Re: Docket No. 70-925; License No. SNM-928
Redefining the Licensed Area

Mr. Ken Kalman, et. al.
Redefinition of the Licensed Area
June 7, 2019

ATTACHMENT 1
PROPOSED REVISED FIGURES 6-1 THROUGH 6-3
FACILITY DECOMMISSIONING PLAN – REV 1

ATTACHMENT 2
PROPOSED REVISIONS TO SECTION 6.3
FACILITY DECOMMISSIONING PLAN – REV 1

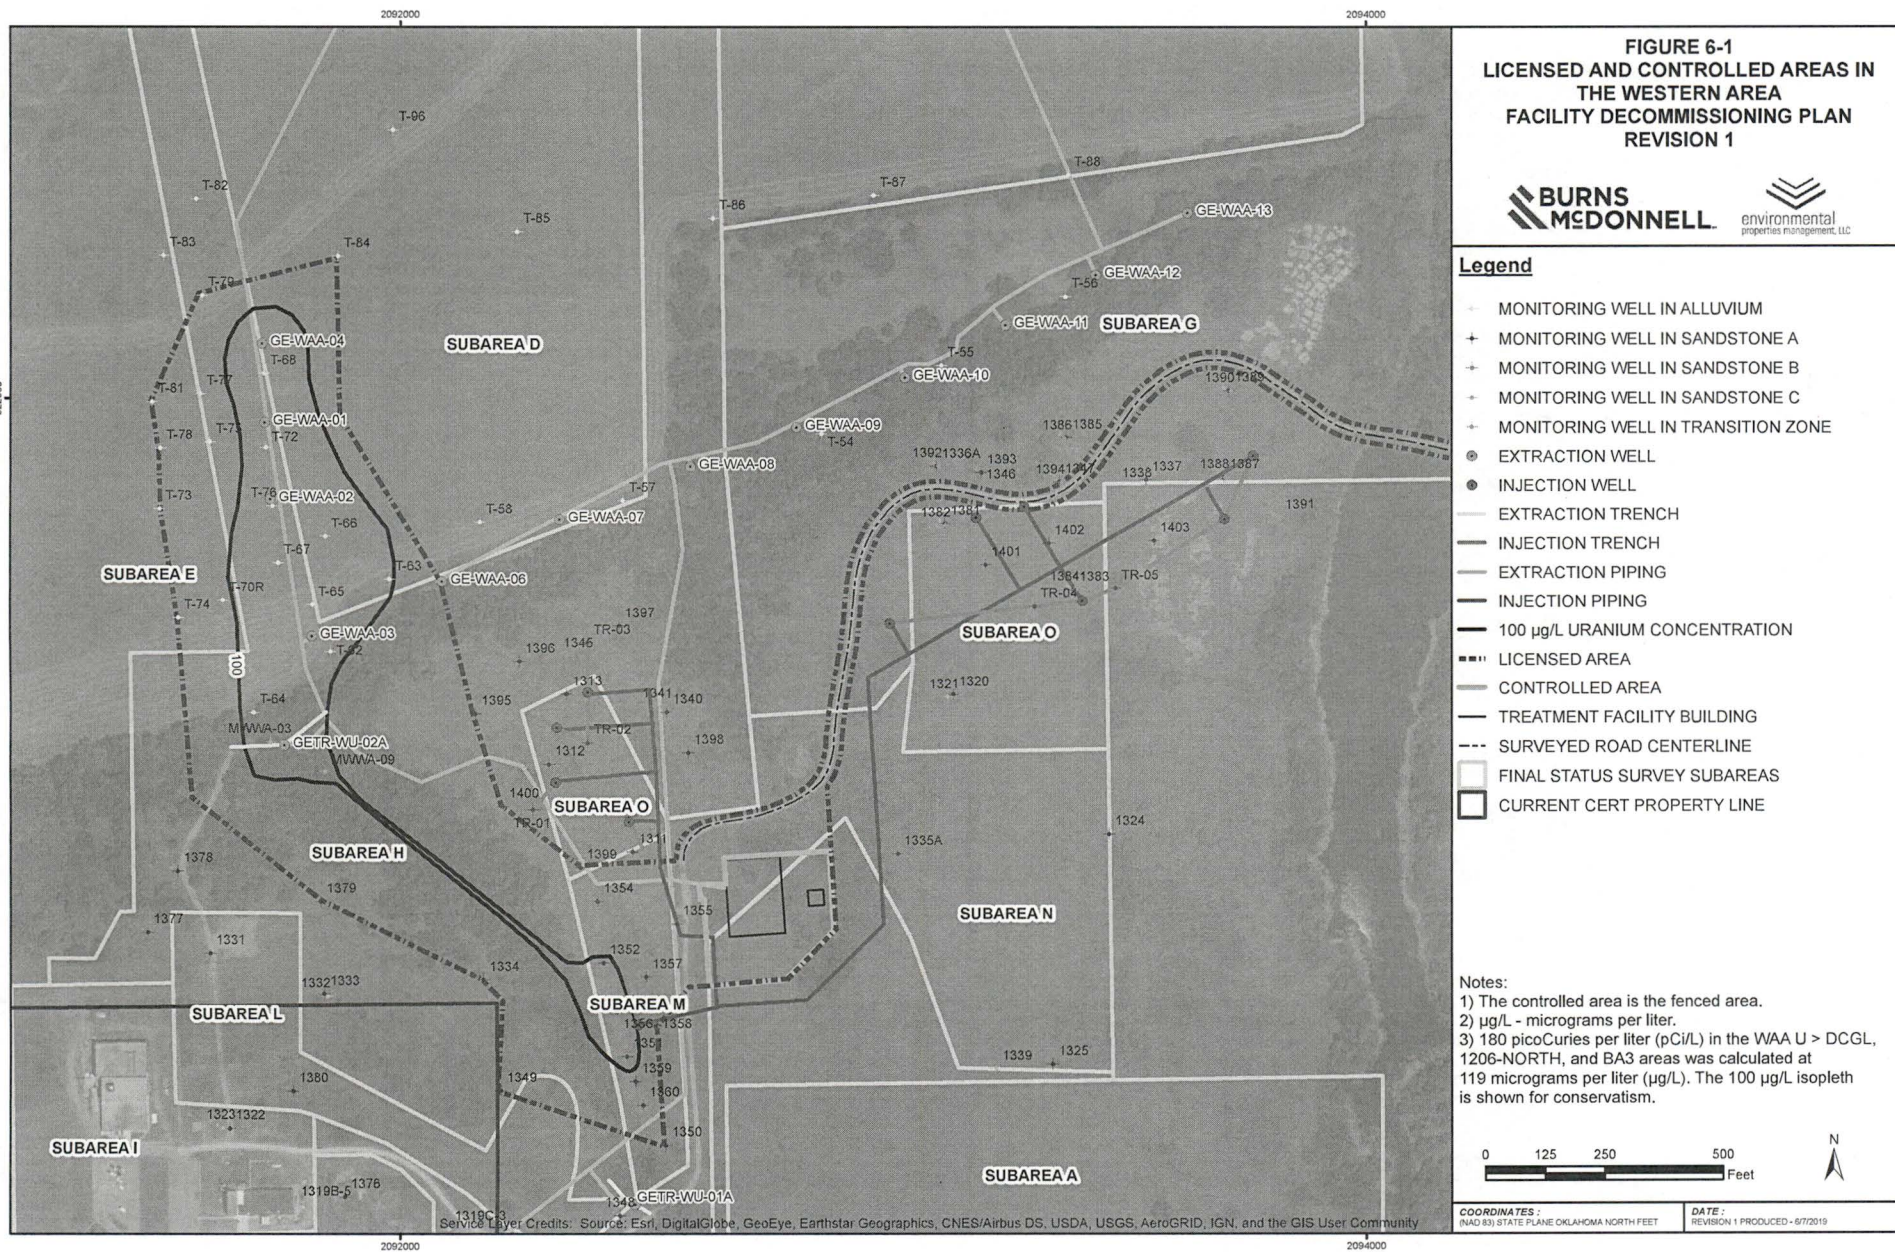
The proposed licensed area in the western portion of the Site was depicted in Figure 6-1 of the DP. The proposed licensed area in the eastern portion of the Site was depicted in Figure 6-2 of the DP. During their review of the DP, NRC personnel observed that those figures, while delineating the proposed areas that would be under license, did not show the extent of groundwater which contains uranium that exceeds the license criteria. Consequently, it is difficult for NRC personnel to confirm that the proposed licensed areas do include all the areas within which groundwater exceeds license criteria.

The proposed licensed area in the western portion of the Site is shown in Figure 6-1. Figure 6-1 shows that portions of Subareas D, E, G, H, M, N, and O will be included in the proposed licensed area in the western portion of the Site. It also shows the extent of groundwater in which uranium exceeds 100 µg/L (from Figure 3-3). Because the DCGL is equivalent to approximately 119 µg/L, Figure 6-1 shows that the proposed licensed area will include all groundwater exceeding the DCGL, plus a buffer area.

Attachment 1 to this letter provides revised Figures 6-1 and 6-2 for the DP. The proposed revised figures include Subarea boundaries and isopleth lines that depict the extent of uranium in groundwater exceeding license criteria.

FIGURE 6-2 LICENSED AND CONTROLLED AREAS IN BURIAL AREA #1 FACILITY DECOMMISSIONING PLAN REVISION 1

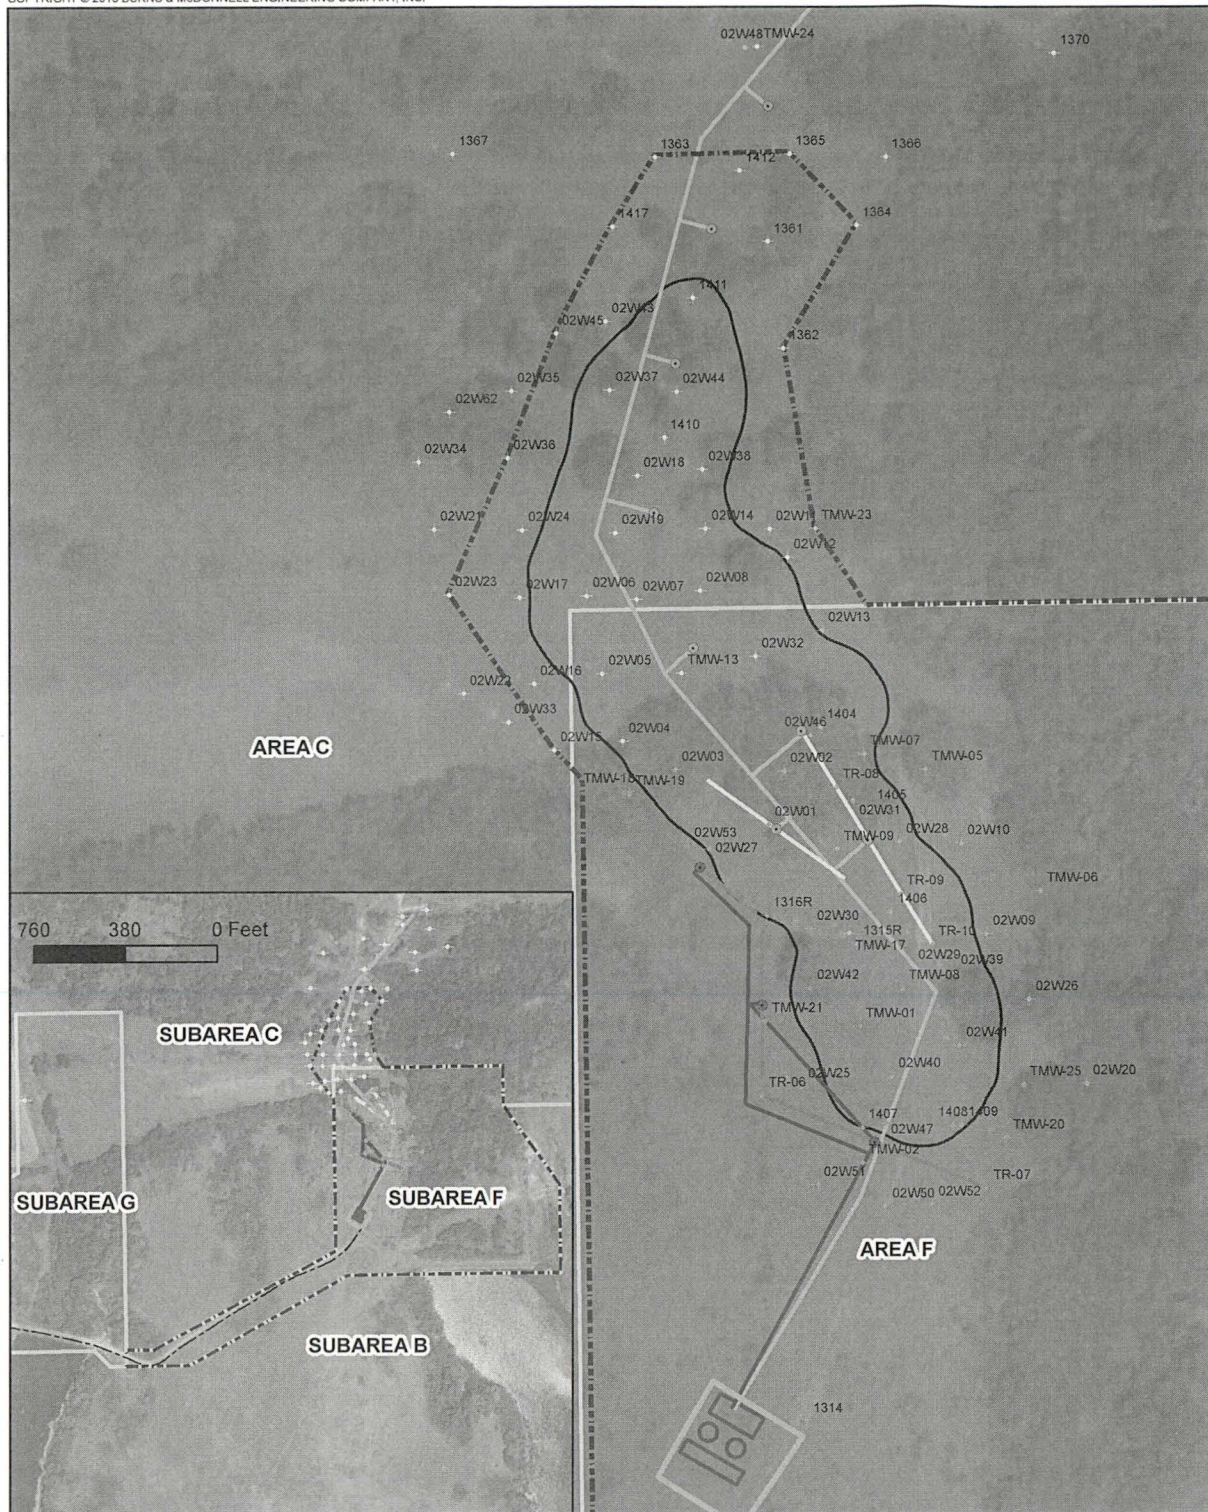
The NRC has expressed concern that the proposed licensed area depicted in Figure 6-2 includes only a portion of Subarea F. Should the NRC amend the license in accordance with the license amendment requested in the DP, they would in effect be releasing most of Subarea F from the license. Although the licensee has completed final status surveys, and the NRC has performed confirmatory surveys for the formal burial trenches and the concrete rubble in Subarea F the final status survey and confirmatory survey process has not been completed for the entire Subarea. Consequently, EPM revised Figure 6-2 to include all of Subarea F in the area to remain under license.

The proposed licensed area in the eastern portion of the Site is shown in Figure 6-2. Figure 6-2 shows that a portion of Subarea C and all of Subarea F will be included in the proposed licensed area in the eastern portion of the Site. It also shows the extent of groundwater in which uranium exceeds the DCGL, demonstrating that the proposed licensed area will include all groundwater exceeding the DCGL, plus a buffer area.

FIGURE 6-3
LICENSED AND CONTROLLED
AREAS - SITE WIDE
FACILITY DECOMMISSIONING PLAN
REVISION 1

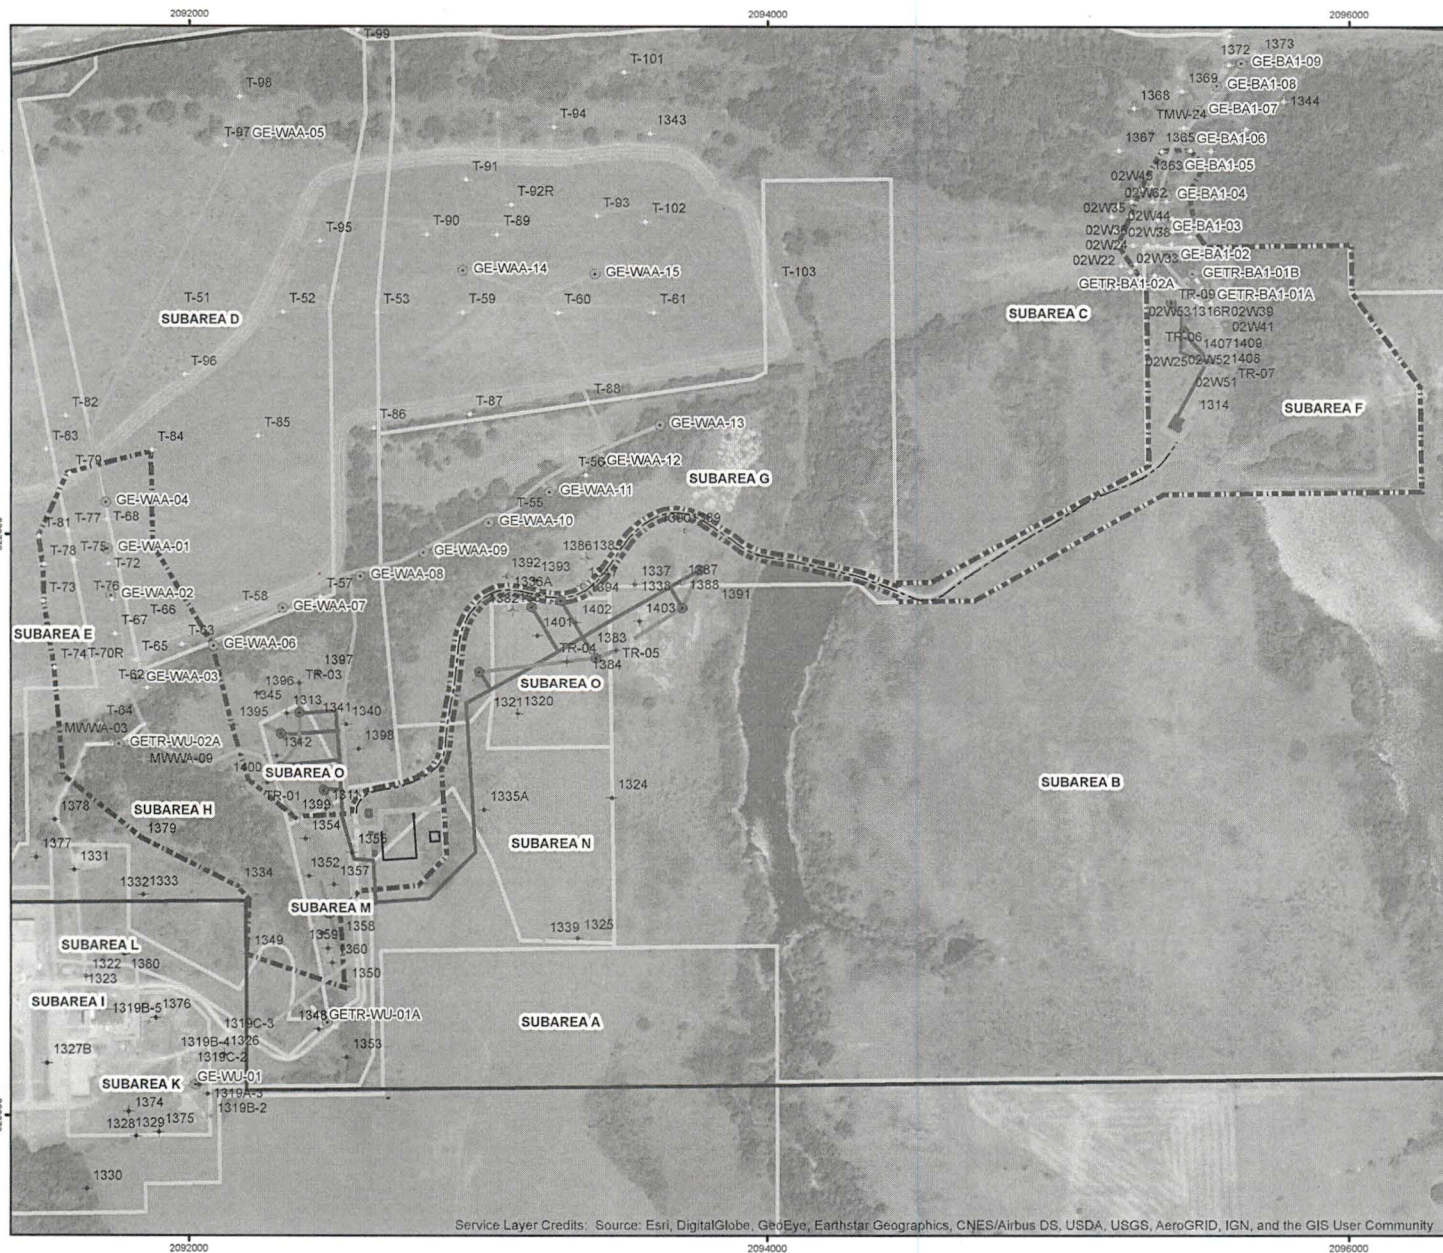
Attachment 1 to this letter provides revisions to Figures 6-1 and 6-2, and includes a new Figure 6-3, which depicts the areas shown in Figures 6-1 and 6-2, extending the licensed area along the road over which spent resin will be transported from the BA1 treatment facility to the WATF for processing, packaging, and shipping. Attachment 2 contains proposed revisions to Section 6.3 of the DP, which requests a license amendment to redefine the licensed area as the area shown in Figures 6-1 through 6-3.

Vessels containing spent resin will be transported from the BA1 treatment facility to the WATF along this road. Figure 6-3 depicts the entire proposed licensed area, which includes portions of Subareas C, D, E, G, H, M, N, and O. This figure shows that a "corridor" extending 5 meters from either side of the centerline of the site road has been added between the two large licensed areas. Vessels containing spent resin will be transported from the BA1 treatment facility to the WATF along this road.
